APPLICATION NO.	FILING DATE	FIRST NAMED INVENTOR	ATTORNEY DOCKET NO.	CONFIRMATION NO.
10/578,001	05/03/2006	Shunpei Yamazaki	740756-2967	3719
22204 NIXON PEABO	7590 11/04/200 ODY, LLP	EXAMINER		
401 9TH STRE		KARIMY, MOHAMMAD TIMOR		
SUITE 900 WASHINGTO	N, DC 20004-2128	ART UNIT	PAPER NUMBER	
			2894	
			MAIL DATE	DELIVERY MODE
			11/04/2009	PAPER

#### **DETAILED ACTION**

3. Claims 1-8, 9-10, 16 and 18-19 are rejected under 35 U.S.C. 102(b) as anticipated by Nishio et al. (US Patent 6,046,547) or, in the alternative, under 35 U.S.C. 103(a) as obvious over Nishio et al. in view of Chen (US Patent 6,211,067 B1).

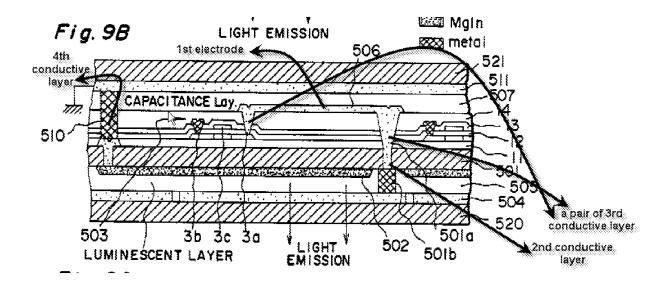
With respect to claim 8, Nishio discloses in figures 1-10, a display device comprising:

- a first insulating layer 505 having a first opening (Fig. 9B);
- a first conductive layer 501b fitted in the first opening (Fig. 9B);
- a second conductive layer (lower portions of 501a in layer 501) on and in contact with the first insulating layer 505 and the first conductive layer 501a (Fig. 9B);
- a semiconductor layer (3a-3c) over the second conductive layer with a gate insulating film 12 therebetween (Fig. 9B);
  - a pair of third conductive layer (see Fig. 9B below) over the semiconductor layer;

wherein the first conductive layer 501a is thicker than the second conductive layer in a vertical direction (see Fig. 9B below), and

wherein the surface of the insulating layer 505 and the first conductive layer is planarized and a uniform surface (see Fig. 9B, wherein the insulating layer 505 and the first conductive layer 501b have a planarized and uniform surface), and

wherein the fourth conductive layer is thicker than the pair of third conductive layer (see Fig. 9B below).

Though Nishio shows planarized and a uniform surface for the conductive layer 501b and the insulating layer 505; however, if it is determined that Nishio does not teach a planarized and uniform surface for the conductive and insulating layers, then Chen patent teaches planarizing the surface of metal plugs and insulating layer by using chemical mechanical polishing (CMP) in order to remove surface roughness and irregularities (Fig. 1A-1E). Nishio and Chen are analogous art (both deal with metal or conductive layers in insulating layers). At the time of the invention, it would have been

Examiner submits that the surface of the first conductive layer 501b and the insulating layer 505 is planarized and constitutes a uniform surface (note the smooth surface of layer 505 and plug 501b in Fig. 9B). However, if it is determined that Nishio does not teach a planarized and uniform surface for the insulating layer 505 and the first conductive layer 501b, then Chen expressly teaches the planarization of conductive layer and insulating layer in order to remove surface irregularities and unwanted roughness through a CMP process (see figures 1A-1E).
